Centre Plan Package A | Developer letters and submissions

(February 23 – May 8, 2018)

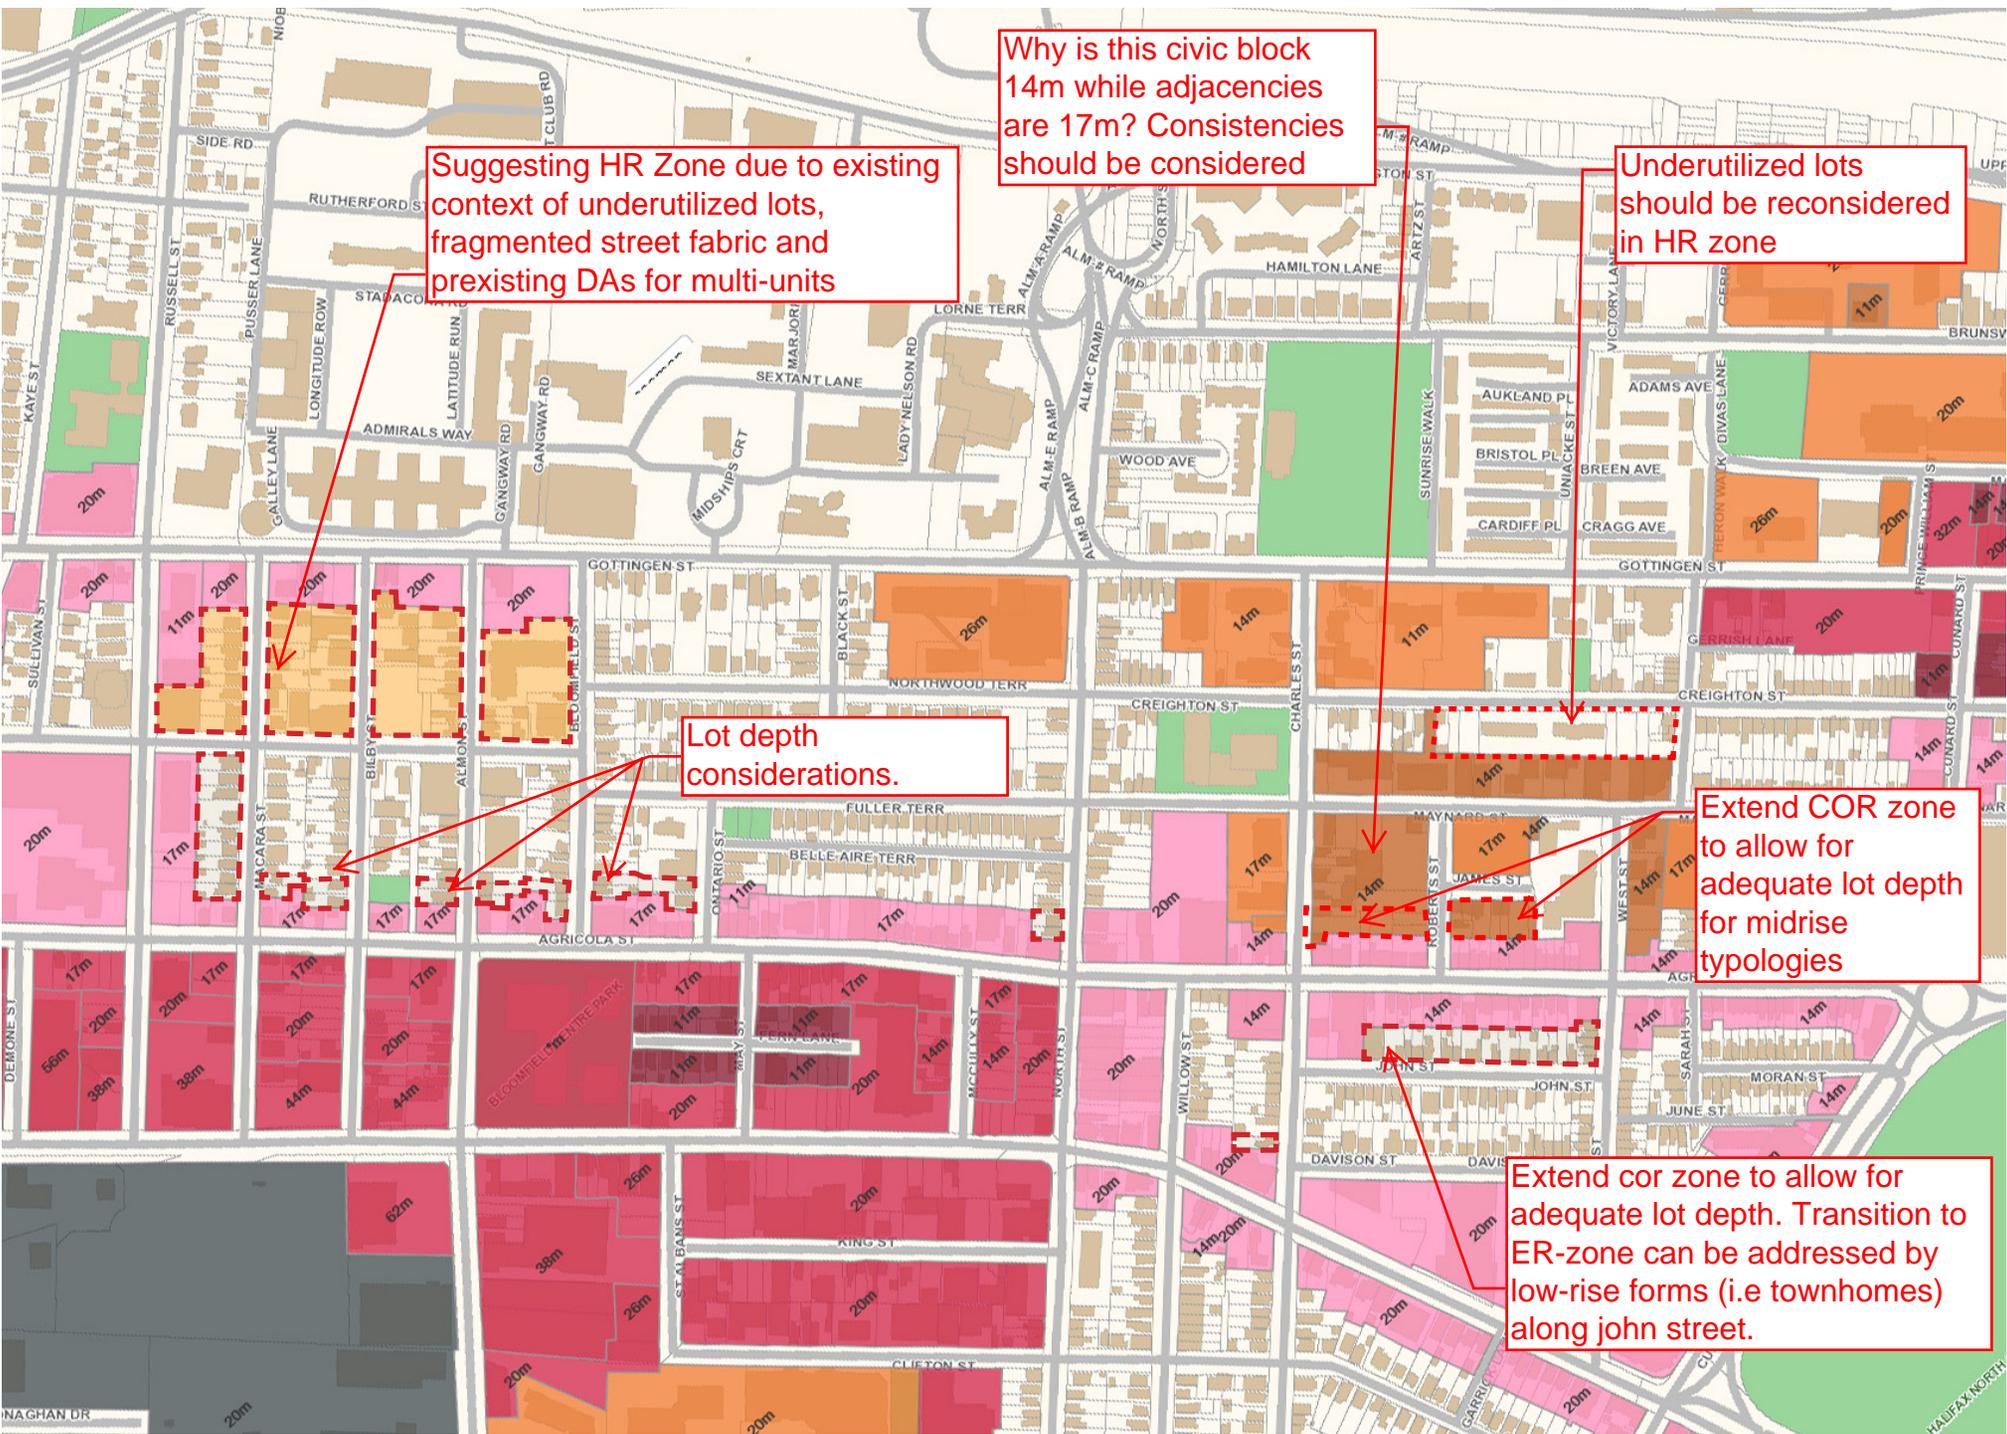
Why is this civic block 14m while adjacencies are 17m? Consistencies should be considered

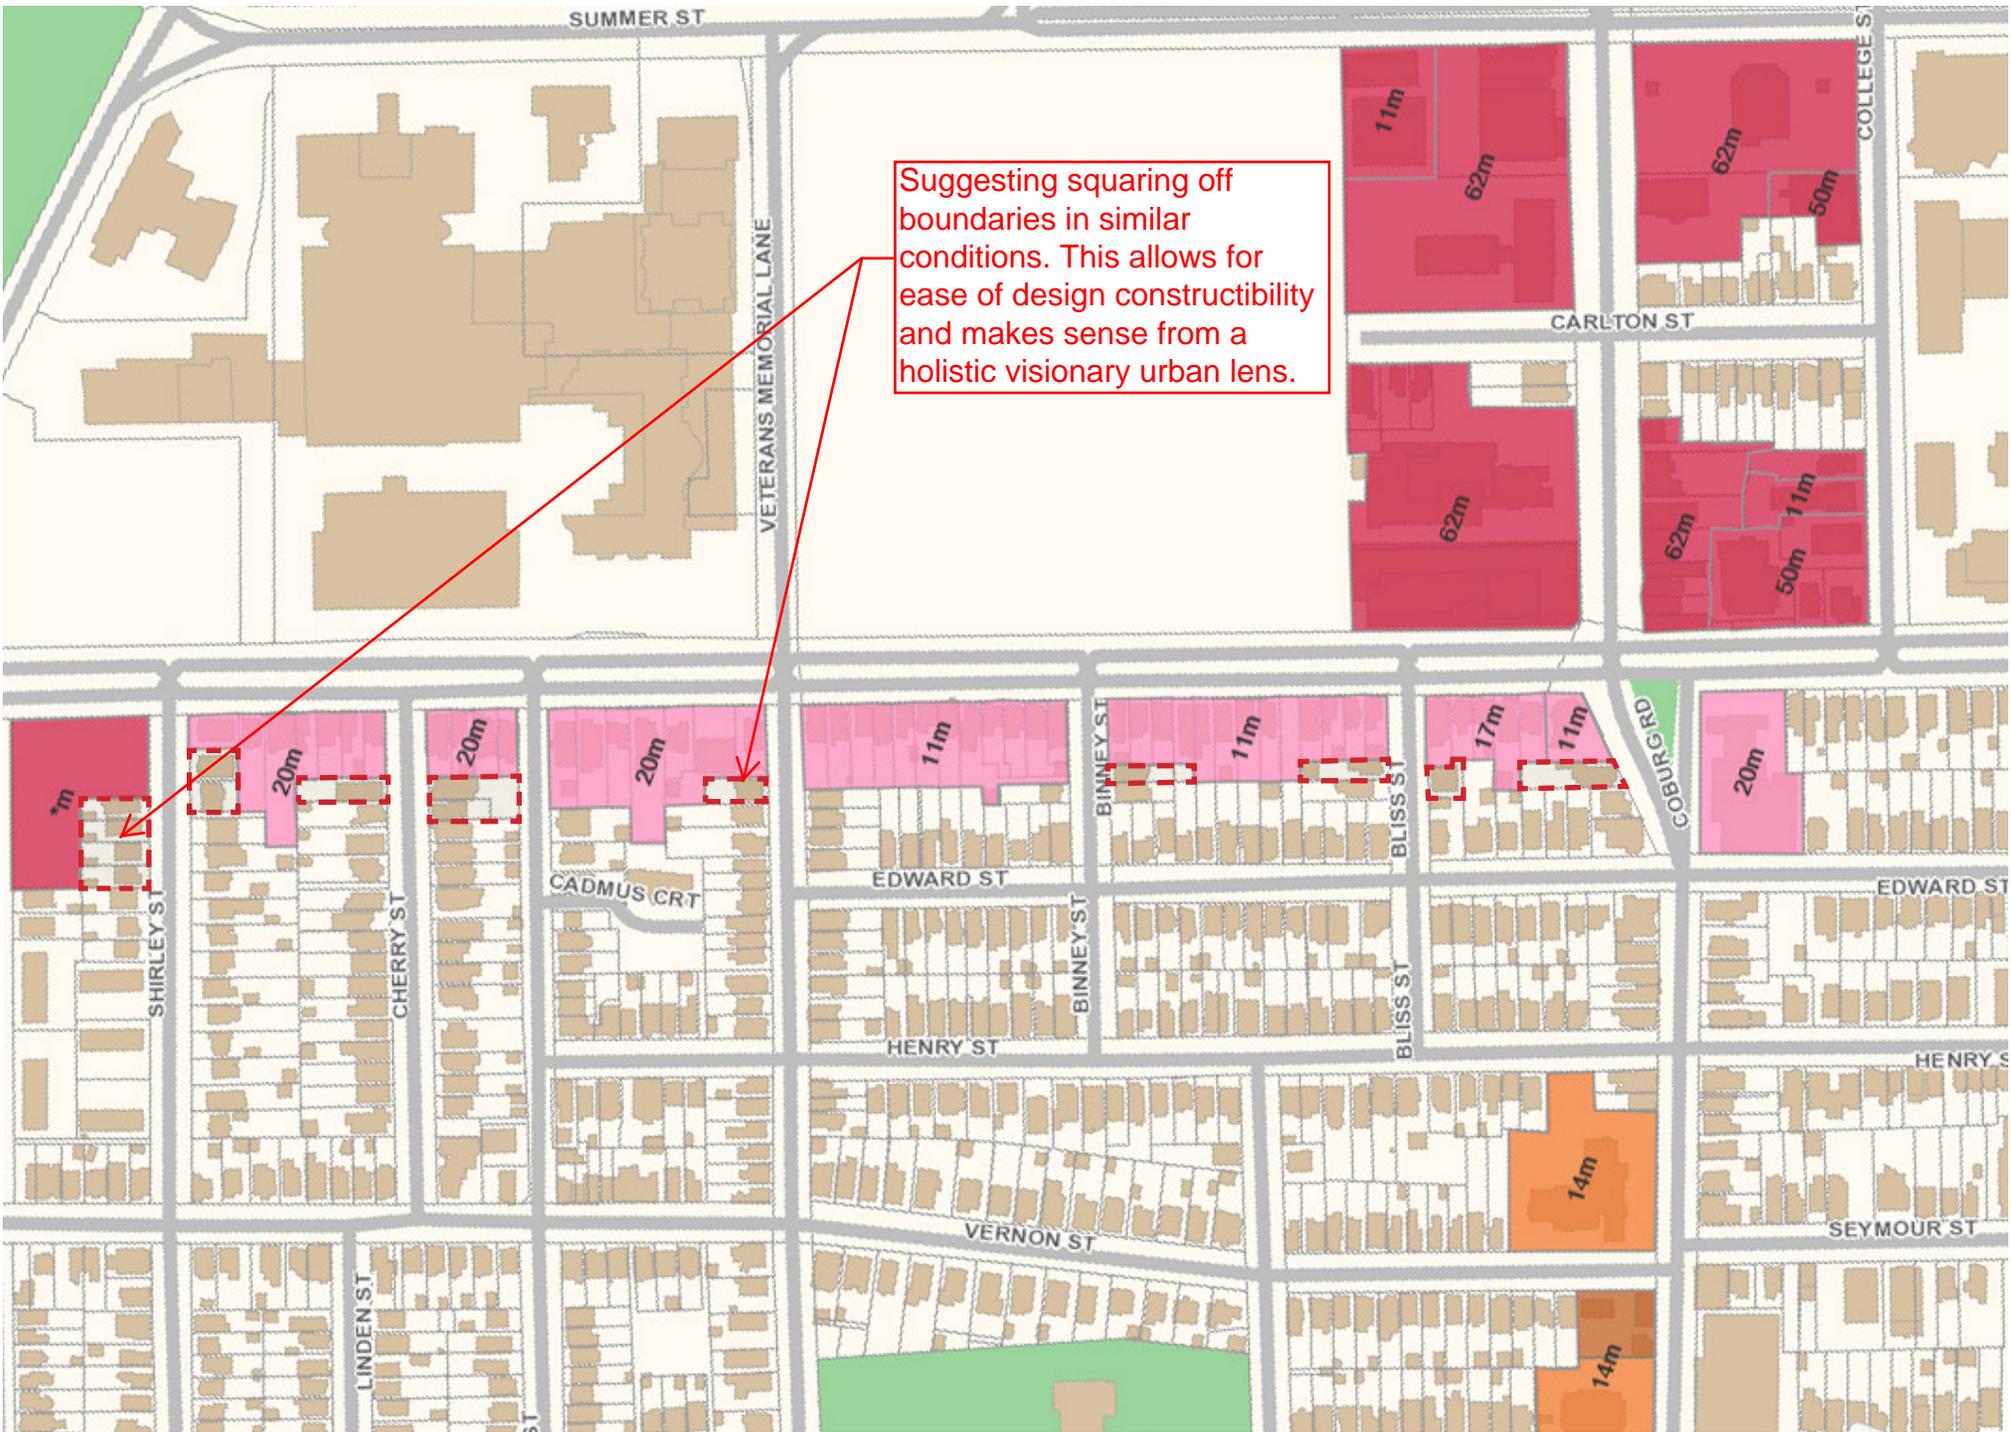
Suggesting HR Zone due to existing context of underutilized lots, fragmented street fabric and preexisting DAs for multi-units

Underutilized lots should be reconsidered in HR zone

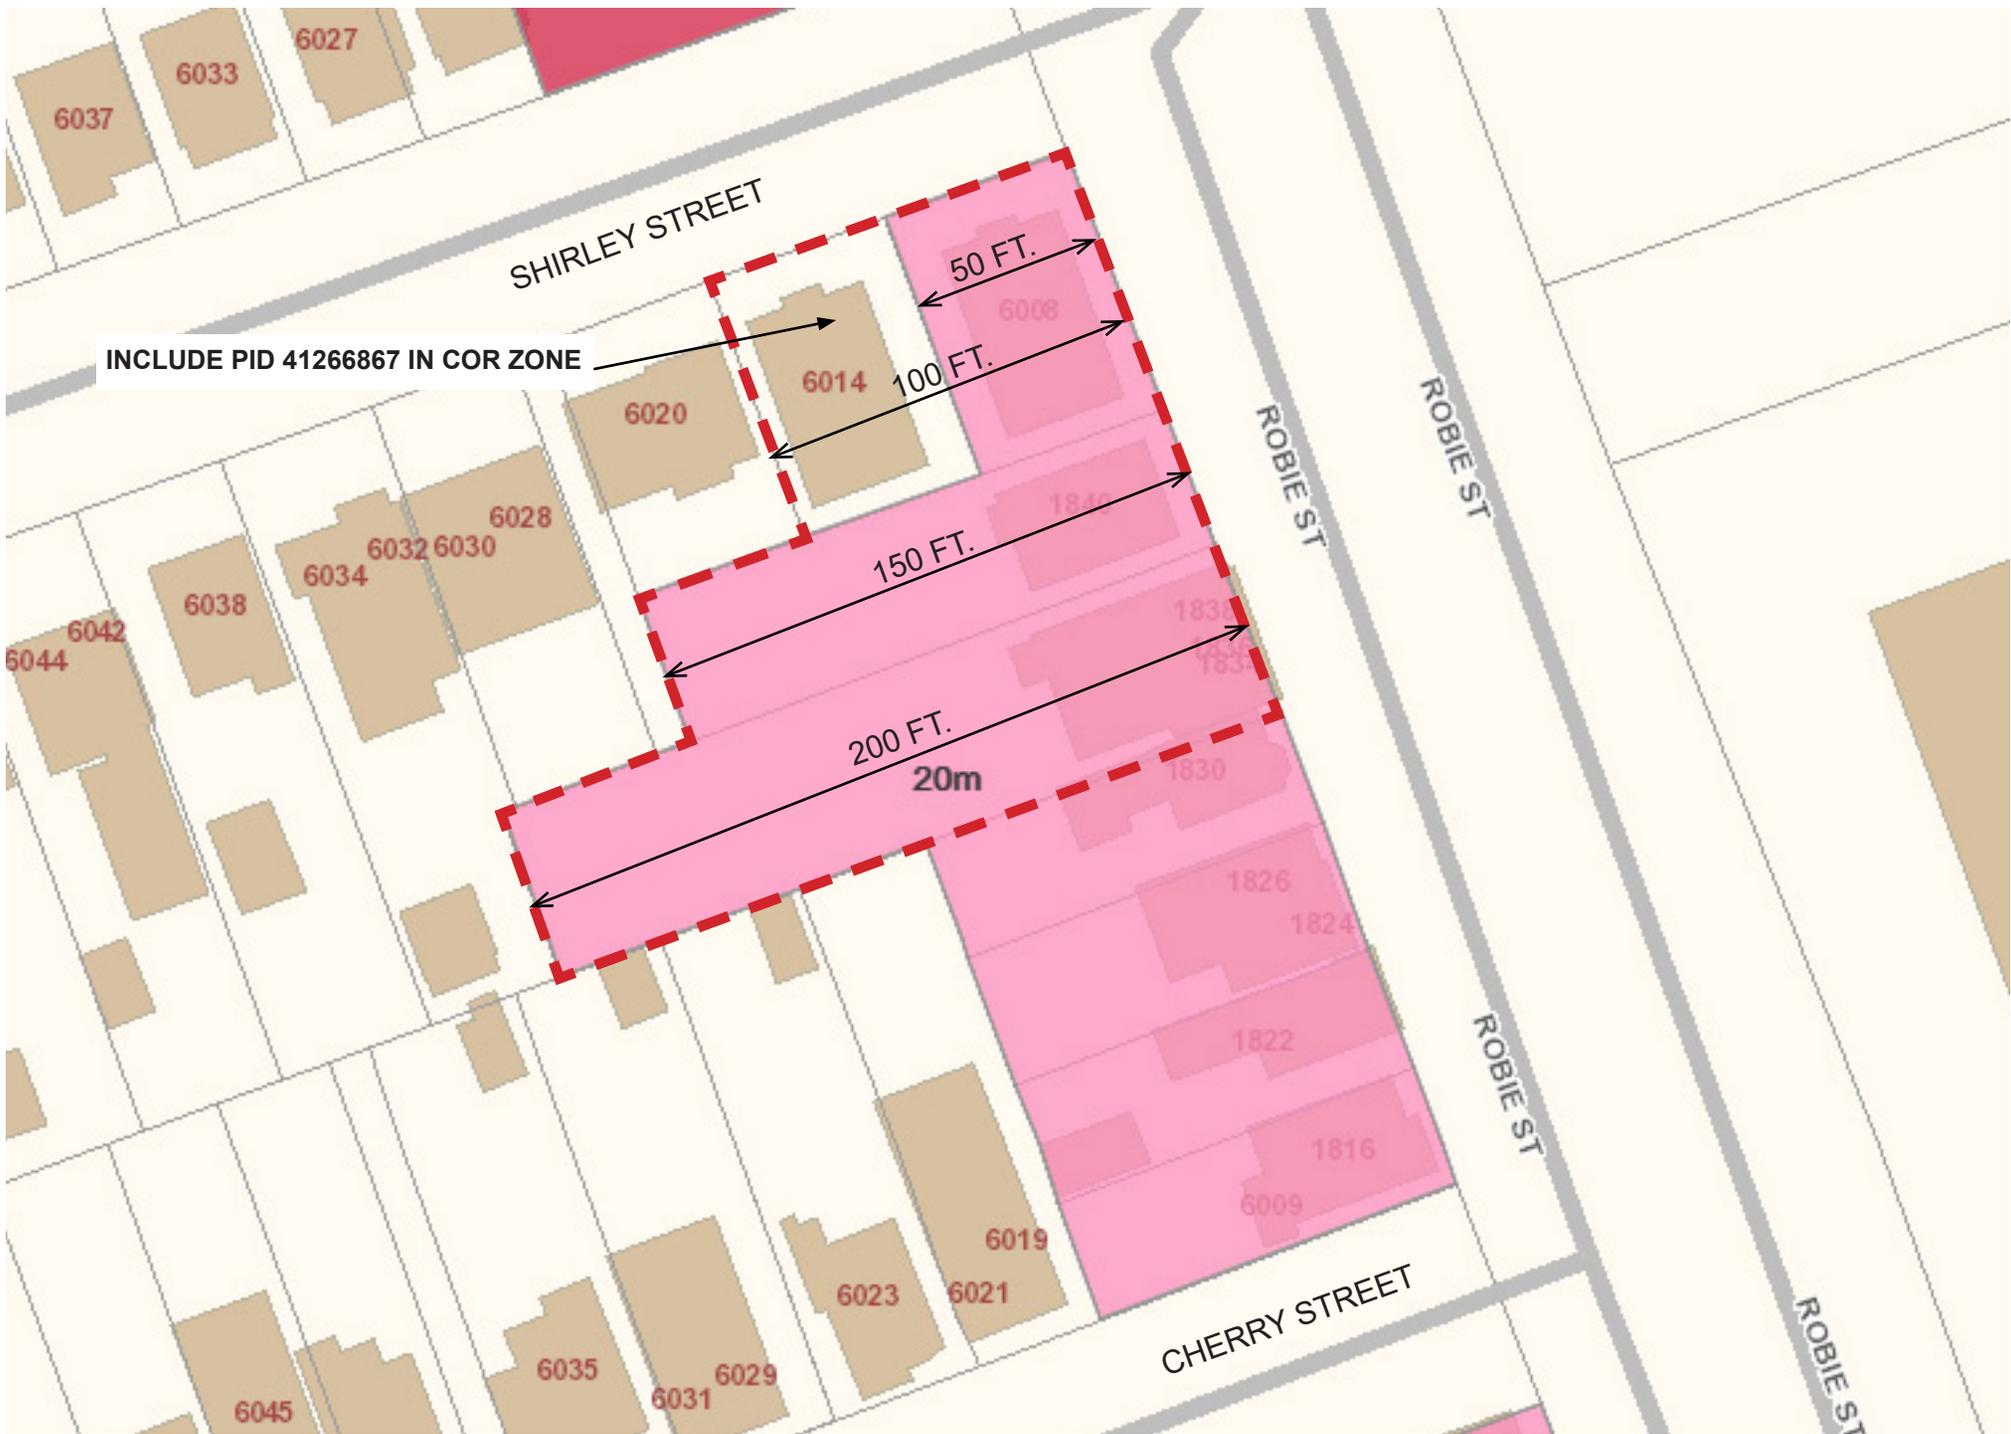
Suggesting squaring off boundaries in similar conditions. This allows for ease of design constructibility and makes sense from a holistic visionary urban lens.

INCLUDE PID 41266867 IN COR ZONE

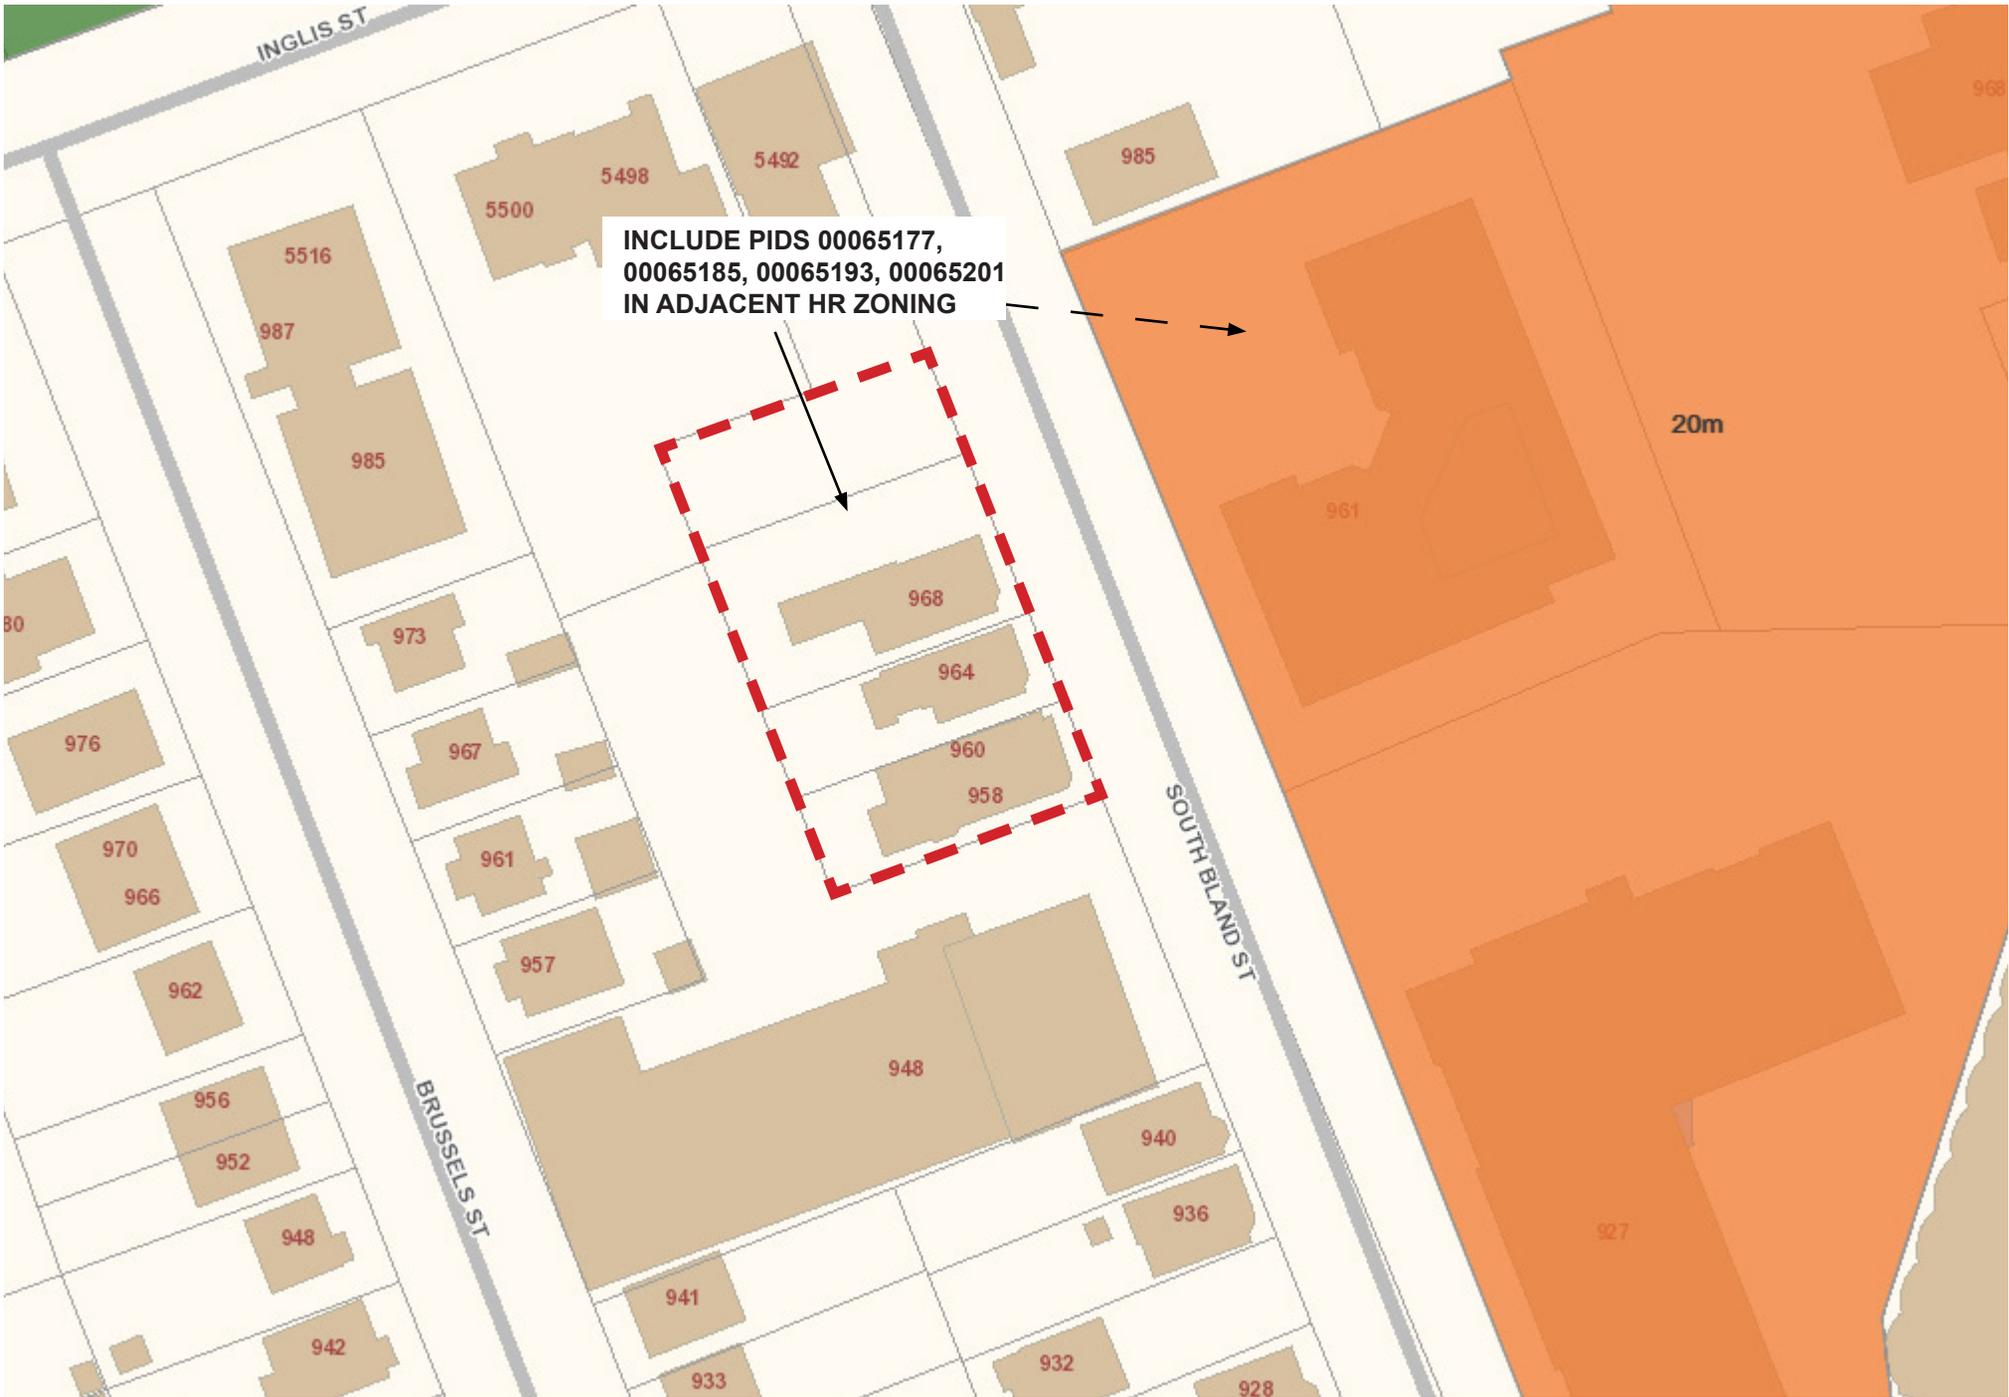
INCLUDE PIDS 40070716, 40437006
IN ADJACENT HR ZONING

INCLUDE PIDS 00065177,
00065185, 00065193, 00065201
IN ADJACENT HR ZONING
